Author's response

Title: A flux tower site attribute dataset intended for land surface modeling

No.: essd-2024-77

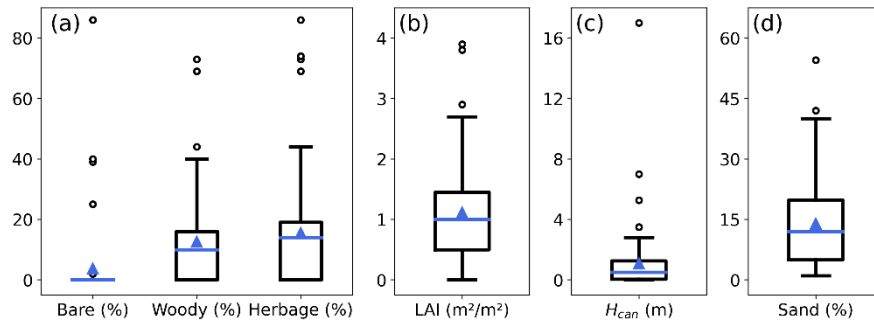
Comment 2: It seems that when vegetation or soil properties data are not available for the sites, the authors use the “default data” instead in order to fill the missing data. I believe the authors should provide some information about potential inhomogeneities in the final dataset resulting from this choice. If I understand correctly, the default data used to fill missing data here are those also shown in Figure 3 as comparison. I would recommend the authors use the sites for which both data sources are available to provide some quantification of the difference between new in-situ data and default data, thus

quantifying the resulting inhomogeneities in the final data product. Some of this information may already been shown in Figure 3, but I recommend the authors quantify this explicitly as it is an important feature of the data produced here.

Response2: We completely agree with your suggestion. It is necessary to account for potential inhomogeneities in the final dataset resulting from data filling. Figure 3 shows the discrepancies between site data and default data to demonstrate the importance of site data. After careful consideration, we believe that Sect. 3.2 describes the flux tower site attribute dataset. Therefore, the quantification of discrepancies between site data and filled data has been added to Sect. 3.2, illustrating the inhomogeneities in the final dataset due to data filling. The added information is as follows.

Figure 4 quantifies the differences between site data and filled data for sites where both data sources are available, illustrating the inhomogeneities in the final dataset resulting from data filling. Differences in vegetation cover (including bare soil, woody, and herbaceous vegetation) generally fall within 20%, with a minority of sites exceeding 40%. The mean and median LAI differences are approximately 1 m²/m². Canopy height deviations are primarily within 2 m, although a few sites exceed 4 m. Differences in sand content typically remain within 30%, with both mean and median differences below 15%. This quantification suggests that the filled data are generally reliable across most sites.

Revised (Figure 2):

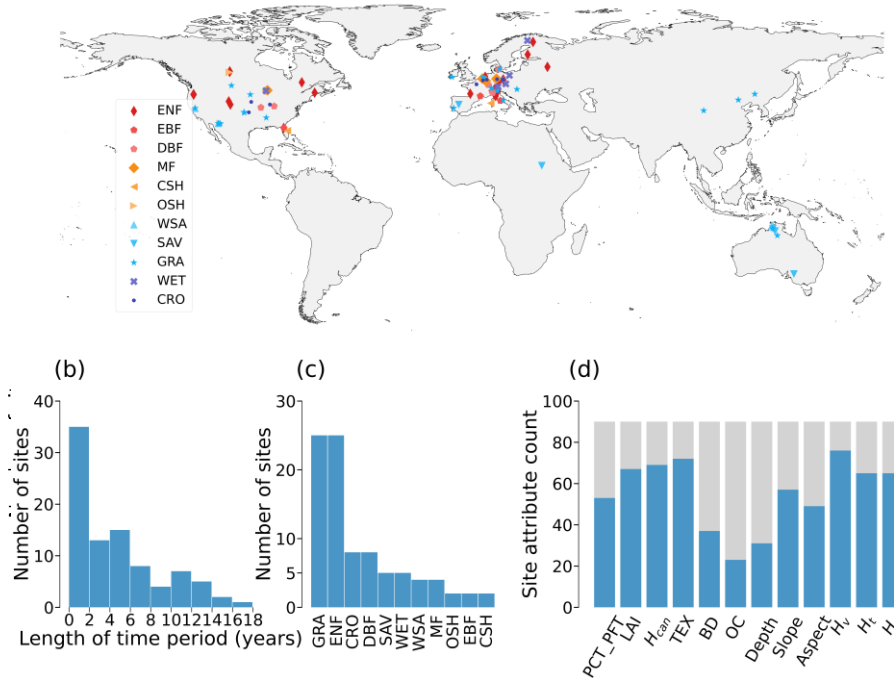
Comment 7 (L76): Why are LAI and canopy height included in the four most important attributes, even though they aren't required as inputs for many LSMs? Soil depth, however, is not mentioned, which can strongly impact model outputs and is required by many LSMs as well.

Comment 23 (Figure 2): Don't you mean "number of years", not "site numbers" in the caption for (b)? In (d), is this the actual number of sites or the percentage? The name Hcan is a little confusing, as you talk about sensible heat flux as H above and here H is height.

Thanks for the reminder. Soil depth is indeed an indispensable variable in LSMs. Therefore, we have added the site soil depth data to the attribute dataset. The dataset is available at <https://doi.org/10.5281/zenodo.12596218>. We have also updated the graphs and related text describing the attribute data.

Response 23: Thanks for your suggestion. In Figure 2 (b), the vertical coordinate is the number of sites, and the horizontal coordinate is the number/length of years.

H (sensible heat) and canopy height (H_{can}) do tend to be confusing, so we plan to change the abbreviations for sensible heat and latent heat to Qh and Qle in the manuscript submission after discussions, and the abbreviation for canopy height will remain the same. Thank you very much for your suggestion.

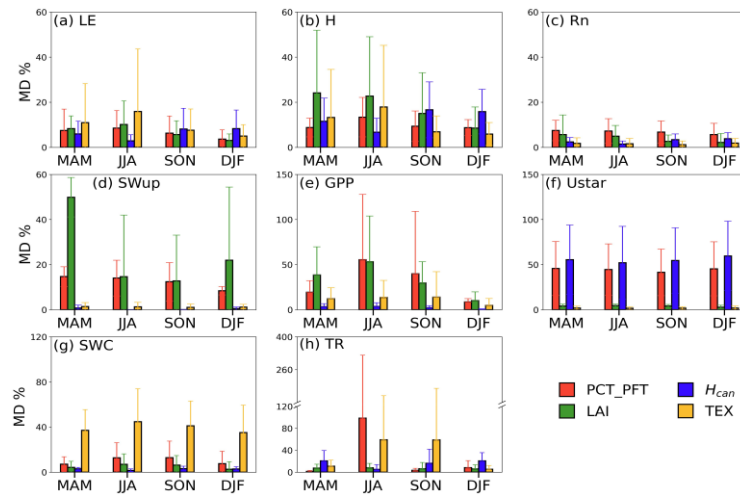
Comment 19 (L224): *Why only the first year and not all available years at the sites? One year could be an unusual/extreme year and not representative of the usual site conditions.*

Response 19: Thank you for your suggestion. It's true that using only one year of data for SPIN-UP is not quite right. Therefore, we have changed the SPIN-UP approach. The new scheme loops the atmospheric forcing data for each site's observation period until it reaches 50 years.

We redrew the pictures associated with the model results (including Figure 4, Figure 5, Figure 6, and Figure 7). Overall, these figures don't change much. And the relevant MD% values in this paper are modified. The comparison before and after modification is as follows:

Revised (Figure 8):

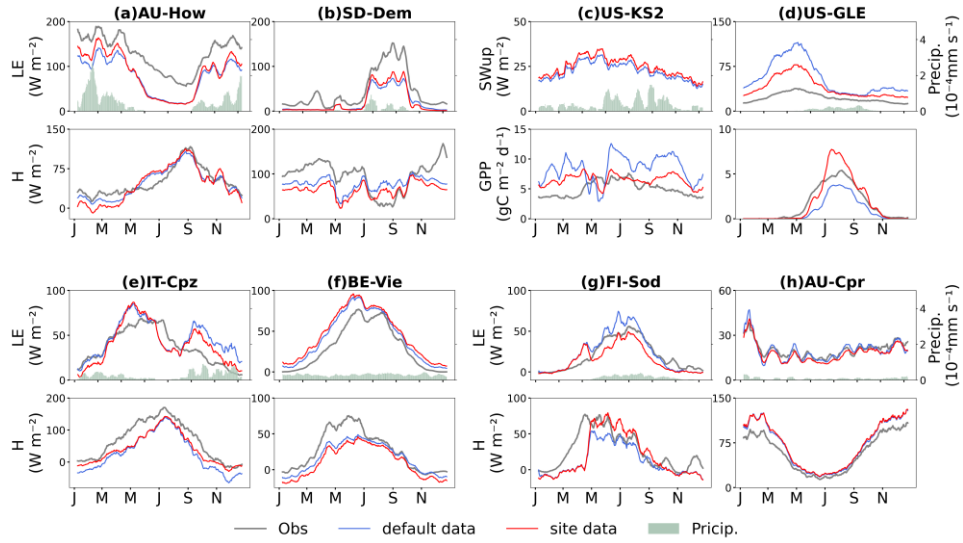
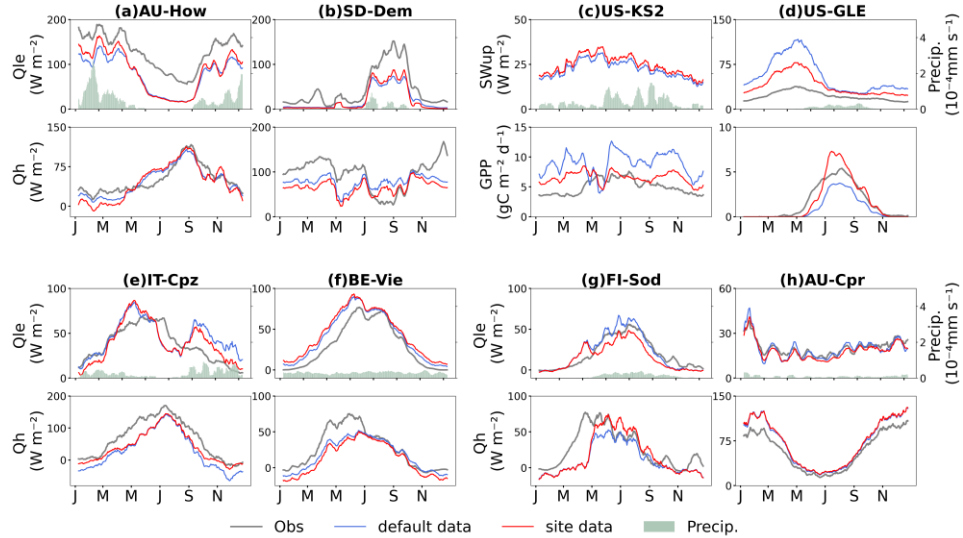
Comment 7 (Figure 7 caption): Do you mean “Precip” in the legend?

Comment 3: Some of the Tables and Figures could be improved by organizing sites in the same order for the different variables that are shown or to show the selected variables for all the sites. For example, Table 2 and Figure 7 could be made clearer.

Comment 31 (Figure 7): *Why do you show SWup and GPP at 2 sites only and don't show the LE and H there? Also, it doesn't seem to show observations for SWup at US-KS2. Why show that variable at that site, if observations were not available? Why were these specific 8 sites chosen for the figure (and not all 36 sites) and why don't you show LE, H, GPP and SWup at all the selected sites?*

Response 7: Thank you for your careful examination. We have revised it.

Figure 7 is intended to illustrate that the impact of attributes is substantially associated with precipitation. We intentionally chose two typical sites for each attribute and formed a contrasting effect to illustrate the important role of precipitation. Therefore, only 8 sites are ultimately shown. We have added this information to the description of Figure 7. Please refer to Response 31 for specific details.

Response 31: Thank you for your question. I'm sorry for the confusion. In the modeling assessment of attribute data, four attributes were selected, and Figure 7 shows two typical sites for each attribute (which can be contrasted to highlight the important role of precipitation). We have added this information to the description of Figure 7.

Figure 7 is intended to illustrate that the impact of attributes is substantially associated with precipitation. We intentionally chose two typical sites for each attribute and formed a contrasting effect to illustrate the important role of precipitation. Therefore, only 8 sites are ultimately shown.

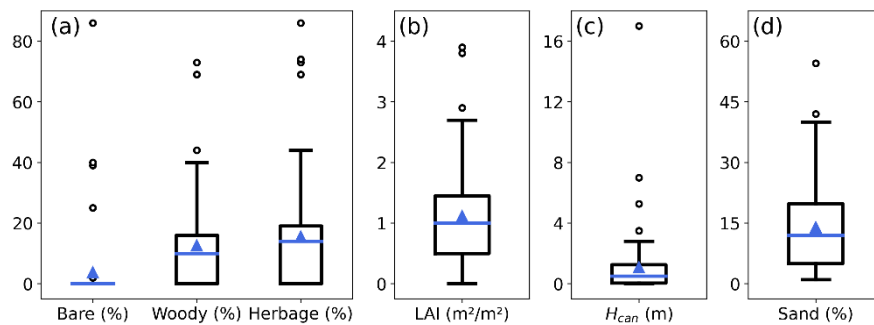
Comment 10 (L90): MODIS v6.1 might be better but uncertainties in remotely sensed LAI can be huge. PLUMBER2 provides two independent LAI for this reason as at some sites LAI estimates are vastly different. I'm not sure providing an estimate from a single dataset is helpful or superior. If anything, it would have been valuable to include more LAI datasets to account for uncertainty and constrain these with site observations where available

Accordingly, we have provided the quantification of uncertainties for the filled data. The discrepancies between site data and filled data have been added to Sect. 3.2, illustrating the uncertainties of the filled data. The added part is as follows:

Figure 4 quantifies the differences between site data and filled data for sites where both data sources are available, illustrating the inhomogeneities in the final dataset resulting from data filling. Differences in vegetation cover (including bare soil, woody, and herbaceous vegetation) generally fall within 20%, with a minority of sites exceeding 40%. The mean and median LAI differences are approximately 1 m²/m². Canopy height deviations are primarily within 2 m, although a few sites exceed 4 m. Differences in sand content typically remain within 30%, with both mean and median differences below 15%. This quantification suggests that the filled data are generally reliable across most sites.
